Re: Peg Broadcasting, LLC  
WTZX(AM), Sparta, TN  
Facility Identification Number: 3341  
File Number: BP-20100222AAZ

The staff has under consideration the above-captioned application for a minor modification of station WTZX(AM).

Title: MAP

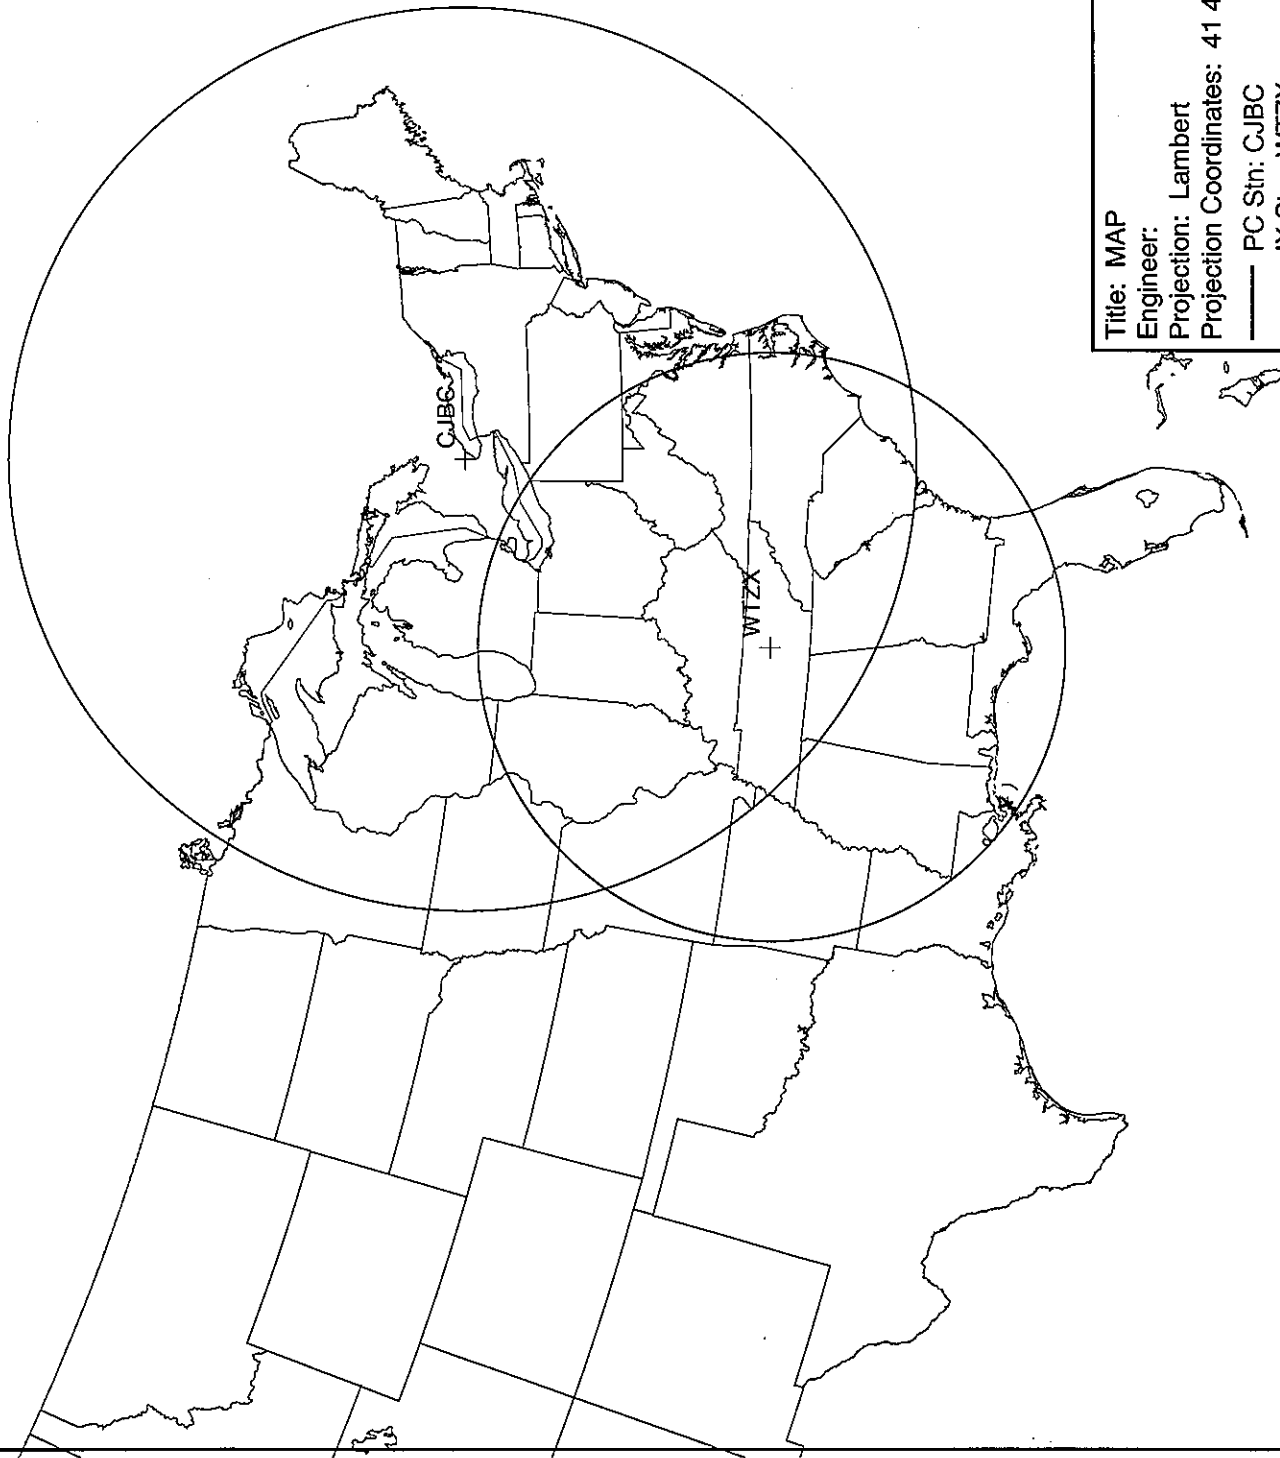
A preliminary engineering review of the application reveals that the proposed nighttime 0.025 mV/m-10% skywave contour would increase overlap the 0.5 mV/m-50% skywave contour of co-channel Class A station CJBC, Toronto, Ontario, in violation of US/Canadian AM Broadcast Agreement. (See attached exhibit).

Accordingly, further action on the subject application will be withheld for a period of thirty (30) days from the date of this letter to provide you an opportunity to submit an amendment. Failure to amend or respond within this time period will result in the dismissal of the application pursuant to Section 73.3568. Please note that any amendment must be submitted in the same manner as the original application.
